Office Action Summary

10/780,382

COLE ET AL.

*Fig. 1*Claim 9:

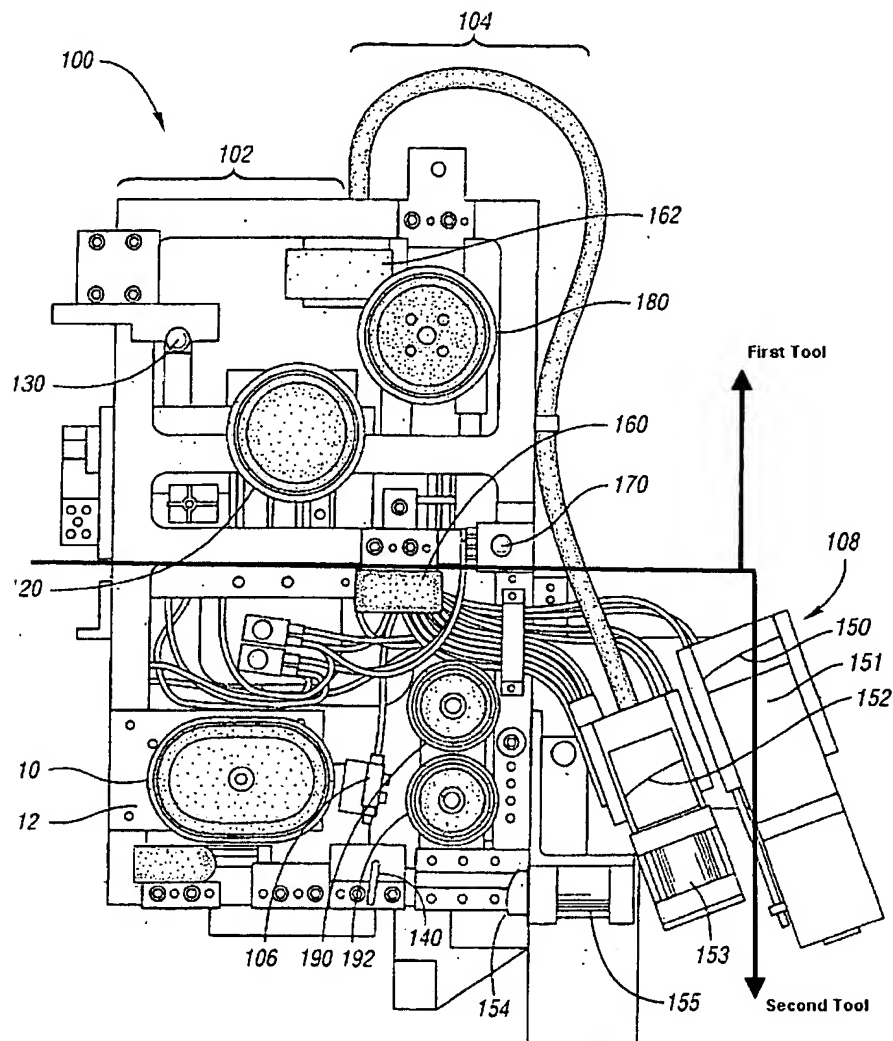
Roy teaches a tool assembly for setting a gap between a pair of panels including a first panel movably attached at a first mounting location and a second panel fixedly attached at a second mounting location, the panels being spaced apart to define a gap between the panels comprising, a first tool (see below) having a first body portion (104) adapted to be releasably attached to the first panel (30), a second body portion (102) adapted to be releasably attached to the second panel (20), and a pin (140) having a predetermined diameter (col. 3, lines 43-46), the first and second body portions and the pin being attached to and movable relative one another (by frame 100), a second tool (see below) having a first body portion(104) adapted to be releasably attached to the first panel (30), a second body portion (102) adapted to be releasably attached to the second panel (20), and a pin (140) having a predetermined diameter (col. 3, lines 43-46), the first and second body portions and the pin being attached to and movable relative one another (by frame 100), a connector member (frame 100) extending between the first and second tools, a control panel (220) attached to the frame (100) for controlling the movement of the body portions and the attachment of the body portions to the panels, whereby the first and second body portions are each attached to the respective first and second panels and the pin extends into the gap between the panels, the second body portion is moved relative to the first body portion until the first and

second panels contact the pin thereby setting the gap at the predetermined diameter (figure 3 and col. 4, lines 14-65).
